FINAL REPORT

Critical Decision (CD)-1 Independent Project Review (IPR)

Savannah River Plutonium Processing Facility (SRPPF)

March 15-19, 2021

Figure S-1 – Manually generated Critical Path coding, SRPPF February 2021 schedule

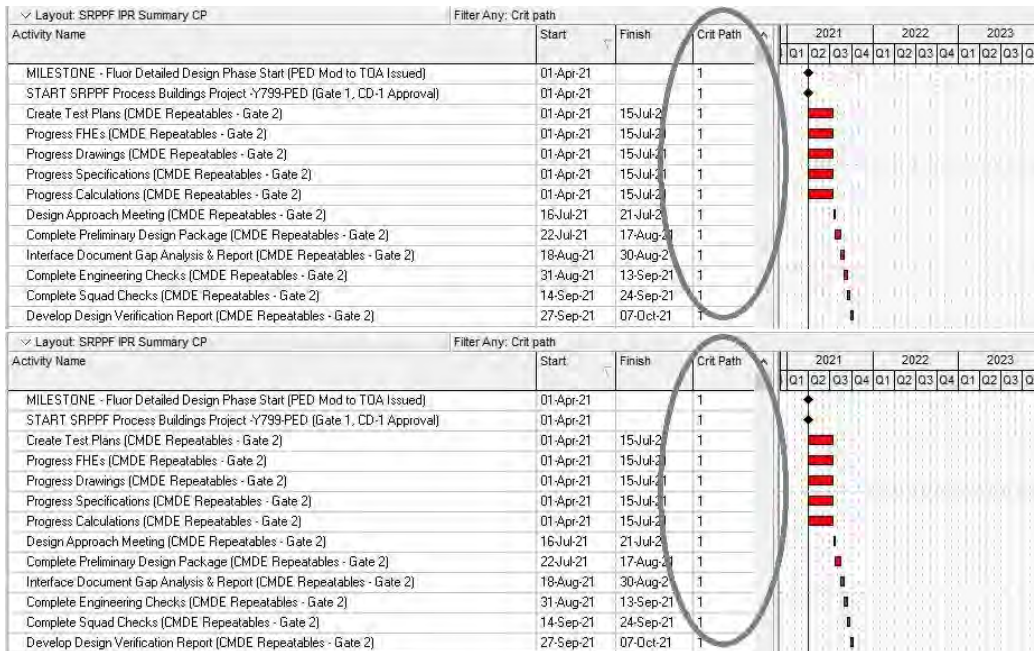
Although the P6 files are interlinked, the critical path is being derived manually. SME input is used to select activities deemed to be critical and then those activities are assigned the code entitled “Crit Path”. (See Figure S-1 below.) The IPT chose the manual method as a stop gap because there are many level of effort (LOE) activities on the software generated critical path. These LOE activities can be expected to move off the critical path once the design matures and activity granularity, logic, and coding is refined.

The IPT is aware that their chosen method of assigning a critical path is not a best practice and has begun the process of improving logic and coding to allow the software to identify critical and near critical activities and calculate critical paths. The POW schedule does not use the manual CP method and allows the software to generate critical paths.

The manually identified critical path runs through the process building scope including, Fluor detailed design start, CD-3E for process equipment engineered procurement, glovebox fabrication and installation, and building 226-F balance of scope work for piping, mechanical, and electrical installation and system tie-ins and testing.

Figure S-6 - P6 calendars – SRPPF schedule

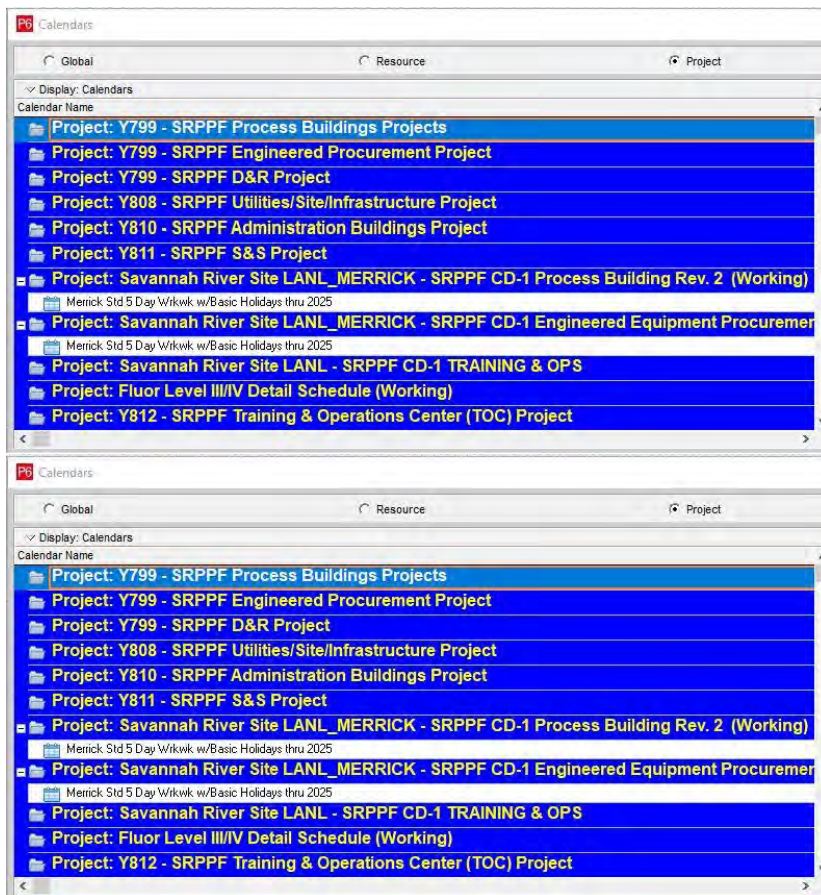
Appropriate work calendars have been assigned to activities throughout the schedule and are specific to the varied work schedules at each site or subcontractor workplace. For example, the 'Merrick Std 5 Day Wk/wk w/Basic Holidays thru 2025' calendar is assigned to work performed by Merrick.

Although the schedule is relatively mature at the pre-CD-1 stage, the review team suggests that the IPT update the planned CD-1 date, ensure all applicable DOE O 413.3B deliverables have been captured, and add margin to the schedule to reflect the CD-4 date accurately. To reduce confusion as to the CD-4 date, any operational and production milestones should be removed and tracked separately from the design and construction schedule.
